FCC Class II Permissive Change Application Letter

Product name : HDMI Wireless Extender
FCC ID: 2ADXC-QAZWSXTX
Date of Grant: 01/02/2025
Model No.: LKV699KVM-V2.0-TX, LKV699-V2.0-TX, LKV677-V2.0-TX,
LKV677KVM-V2.0-TX,, LKV655-V2.0-TX, LKV655KVM-V2.0-TX

Change Contents: Replace the casing and only derive one prototype.

FEDERAL COMMUNICATIONS COMMISSION
AUTHORIZATION AND EVALUATION DIVISION
7435 OAKLAND MILLS ROAD
COLUMBIA, MD 21046

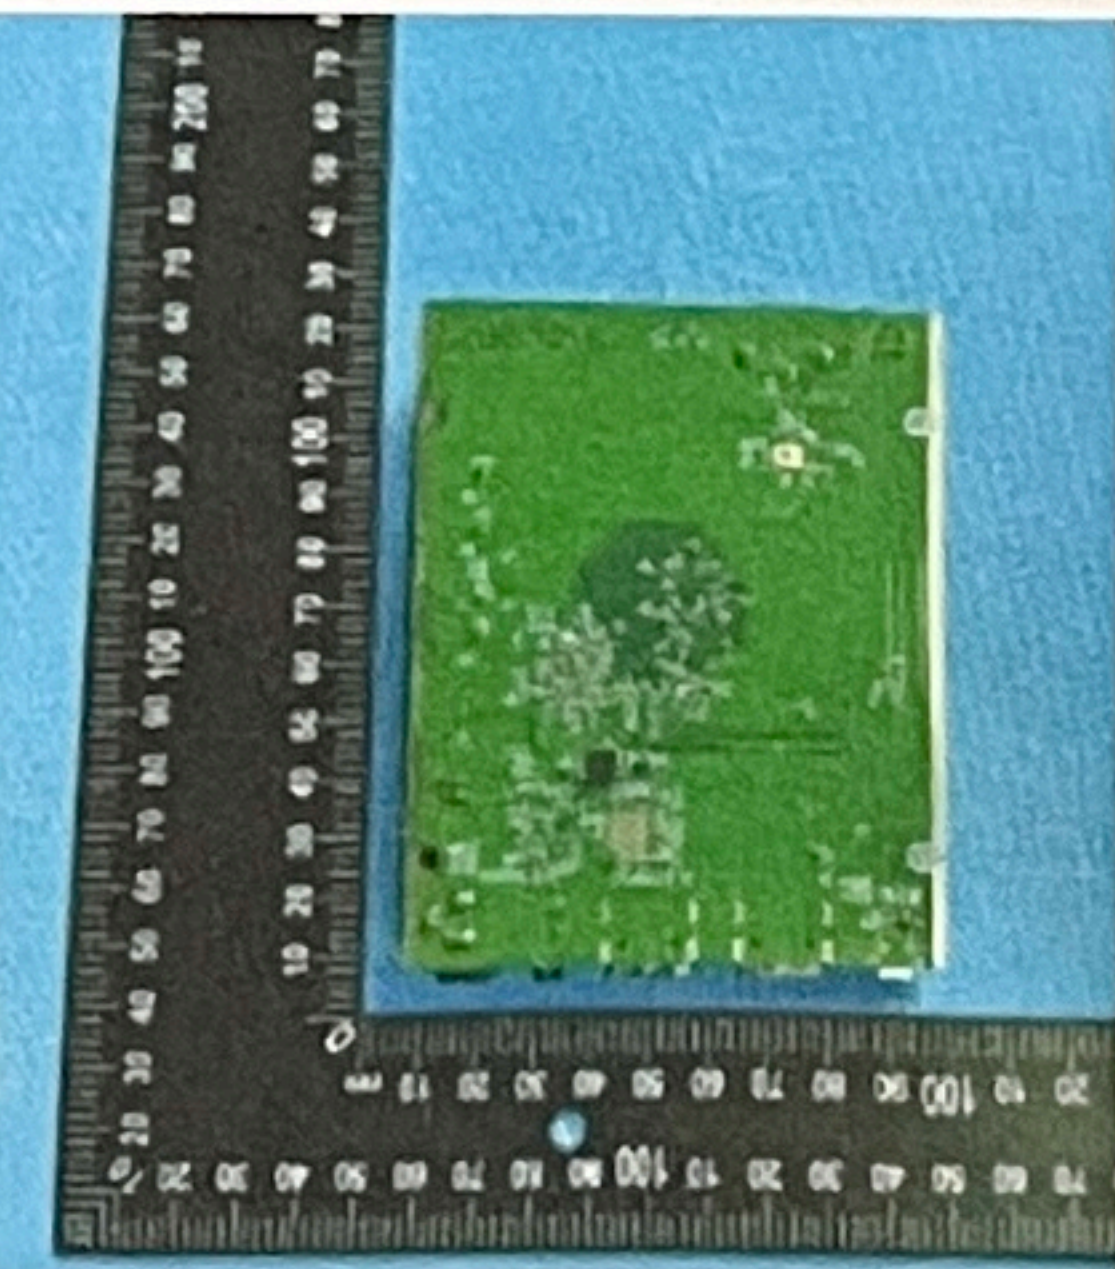
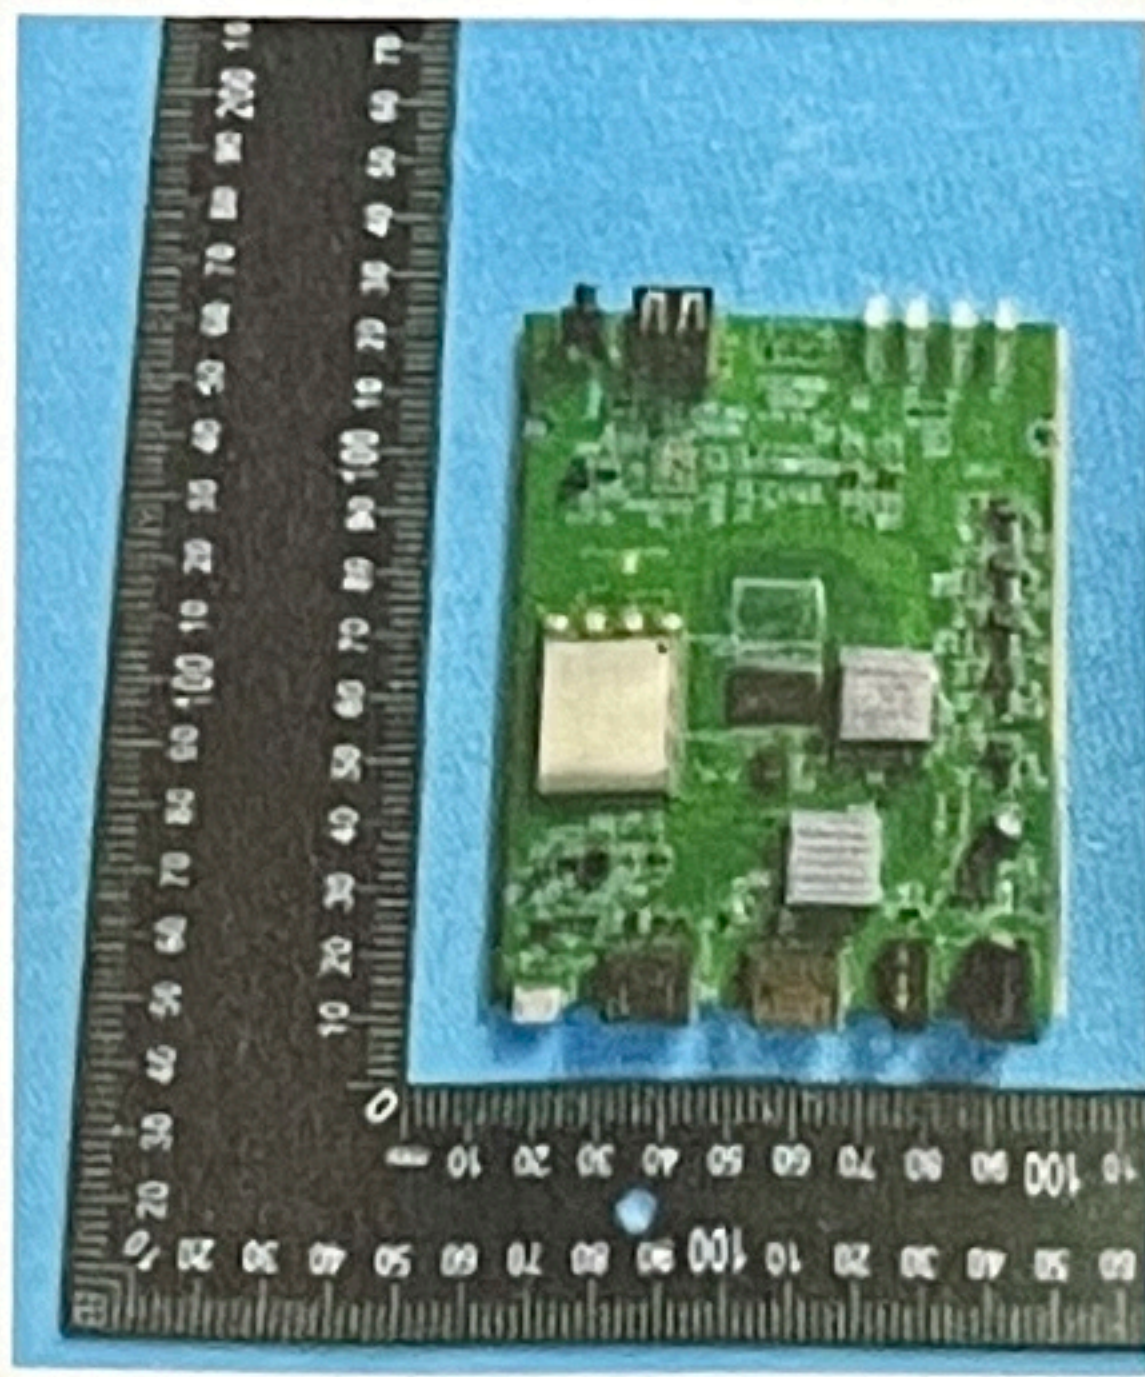
Location	Old PCB of FCC ID: 2ADXC-QAZWSXTX	New PCB of FCC ID: 2ADXC-QAZWSXTX
Product Appearance		
Previously, the shell material was iron, but now it is aluminum. There were originally two PCBA boards, but now there is only one. The change in the material of the casing will not affect the

dimensions of the product.
Modifications that do not change the fundamental RF characteristics and that do not degrade the unwanted emissions of the certified product, please refer to test report for more details; Modifications that do not change physical characteristics significantly. We attach new photographs to identify the modified product.
